**Economic Commission for Europe****Inland Transport Committee****World Forum for Harmonization of Vehicle Regulations****Working Party on Lighting and Light-Signalling****Eighty-fourth session**

**Simplification of lighting and light-signalling UN Regulations:****Simplification of UN Regulations Nos. 48, 53, 74 and 86****Revised proposal for a new [0x] series of amendments to UN Regulation No. 48****Submitted by the Informal Working Group on Simplification of Lighting and Light-Signalling Regulations\***

6.2.6.1.2. **Vertical inclination limits of the cut-off**

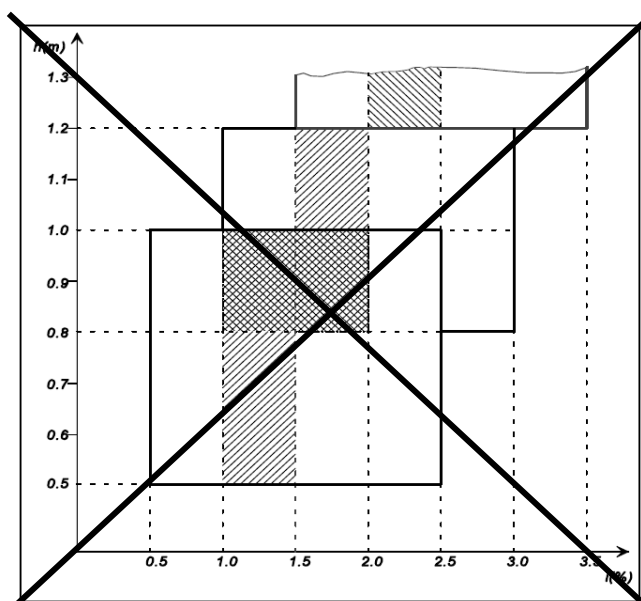
Depending on the mounting height in meters (h) of the lower edge of the apparent surface in the direction of the reference axis of the **passing-beam (dipped-beam) headlamp**, measured on the unladen vehicles, the vertical inclination of the cut-off of the **passing-beam (dipped-beam)**, **starting from the initial downward inclination value set by the vehicle manufacturer as prescribed in paragraph 6.2.6.1.1.**, shall ~~under all the static conditions of Annex 5, remain between the following limits and the initial aiming shall have the following values;~~ **under all the static loading conditions of Annex 5:**

<i>Mounting height h [m]</i>	<i>Upper inclination limit [per cent]</i>	<i>Lower inclination limit [per cent]</i>
$0.5 \leq h \leq 0.9$	-0.20	-1.40 to -1.80*
$0.9 < h \leq 1.2$	-0.20 to -0.85*	-1.80 to -2.45*
$1.2 < h \leq 1.5^{**}$	-0.85 to -1.50*	-2.45 to -3.10*

The above limits and the initial aiming values are summarized in the diagram below.

13. Paragraph 6.2.6.1.2. describes the new requirements for the vertical inclination limits of the cut-off, the provisions of which have been reorganised to improve readability. The vertical inclination values according to the installation height are presented in a table. A new diagram has been inserted providing an illustration of the requirements (aiming in per cent on the horizontal axis and headlamp mounting height in meters on the vertical axis).

15. The vertical line on the left was initially defined at 0 per cent and derived from the GTB study based on the 'Klettwitz study' (informal document GRE-71-32). However, some Contracting Parties were reluctant to have the horizontal cut-off with no downward inclination. At its seventy-eighth session, GRE experts decided to keep the previous vertical limit of - 0.2 per cent.

16. The inclined line on the left (starting from 0.9 m\* in height), results from a mathematical calculation based on the position of the oncoming driver's eyes (at 0.94 m high) for headlamps up to a height of 1.2 m, measured at a distance of 25 m and with an initial aim of 1 per cent down. Using this calculation, it is possible to increase the inclination proportionally to the installation height and still guarantee that glare remains under control; the cut-off line will always stay under 0.94 m at 25 m distance (informal document VGL-10-03, sheet 13).

18. To cover all possible cases of a same type of vehicle (aiming tolerances / chassis deviation / cut-off-line stability / tyre deviation / full or empty tank / levelling device), a range of 1.6 per cent was agreed (see a survey of the International Organization of Motor Vehicle Manufacturers (OICA), informal document VGL-10-10) and used to define the right hand limit and the point (-1.8 / 0.9), based on line defined in item 16.

19. Starting from 0.9 m high, the range of 1.6 per cent is applied to define the line on the right side of the diagram and up to 1.5m.

20. On the right side, under 0.9 m high, there was a compromise to reduce the range progressively to 1.4 per cent at a height of 0.5 m (ECE/TRANS/WP.29/GRE/81, para. 10 and Annex II).

**“The controls for the headlamp-levelling devices referred to in paragraph 6.2.6.2.2. of this UN Regulation**

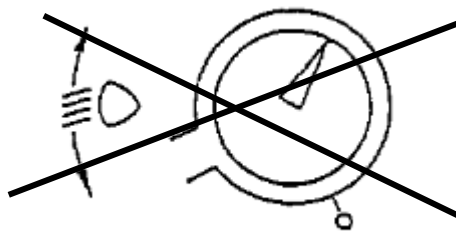
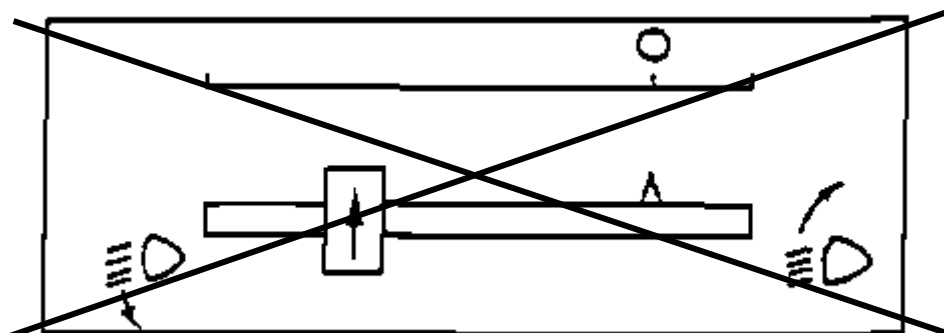
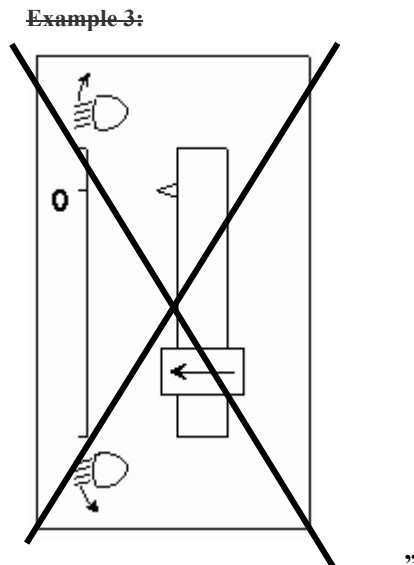
1. Specifications
  - 1.1. ~~Downward~~Inclination of the dipped-beam shall in all cases be produced by a **simple control, the operation of which is clearly described in the owner’s handbook. in one of the following ways:**
    - (a) ~~by moving a control downwards or to the left;~~
    - (b) ~~by rotating a control in a counter clockwise direction;~~
    - (c) ~~by depressing a button (push pull control).~~

A rotary control that is installed edge on, or with only the edge visible, should follow the operating principles of control of types (a) or (c).
  - 1.1.1. This control shall carry symbol(s) indicating clearly the movements corresponding to the downward and upward inclination of the dipped-beam.
  - 1.2. The "0" position corresponds to the initial inclination according to paragraph 6.2.6.1.1. of this Regulation.
  - 1.3. ~~The marks used on control shall be explained in the owner's handbook.~~
  - 1.4. ~~Only the following symbols may be used to identify the controls:~~

Symbols employing five lines instead of four may also be used

- ‘Downward’ should be deleted. In the old text it is referring to the direction of the control device. For trucks dipped-beams are adjusted both upwards and downwards, due to different loading characteristics of different vehicle configurations.
- In order for the requirements to be technology neutral, the prescriptions of control methods (downwards, rotary, push-pull) have been deleted.
- The requirement in para. 1.3., referring to the owner’s handbook, has been moved into the main regulatory text (see paragraph 6.2.6.2.2.[5].) and therefore can be deleted.
- The requirement in para. 1.4., specifying the symbols that can be used, has been deleted as these are already prescribed in UN Regulation No. 121.
- Examples of controls 1, 2 and 3 have been deleted, as the illustrations are considered outdated.

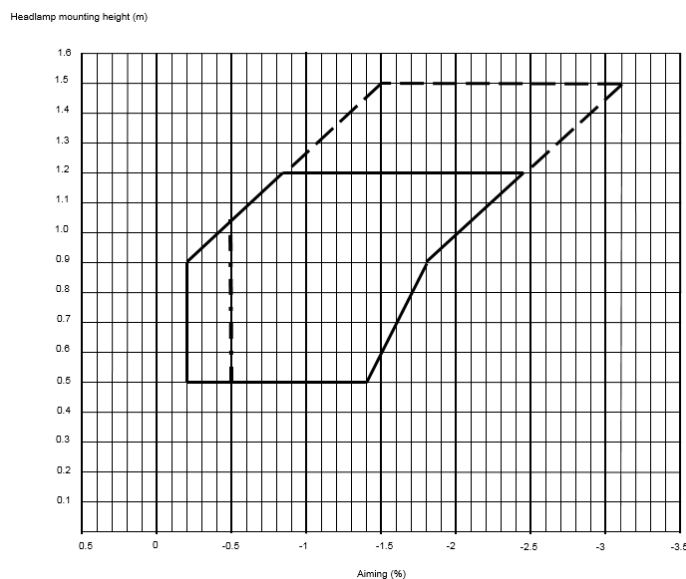
14. Explanations of the lines in the diagram are given below.

17. In addition, the line on the left side of the diagram was extended from a height of 1.2 m to 1.5 m in spite of the fact that, during the Klettwitz tests, no vehicles of categories M<sub>2</sub>/M<sub>3</sub>/N<sub>2</sub>/N<sub>3</sub> were tested. This is the reason the lines above a height of 1.2 m are shown as dotted lines.

21. The vertical dotted line at -0.5 per cent is already explained in item 10 to address the PTI concerns.
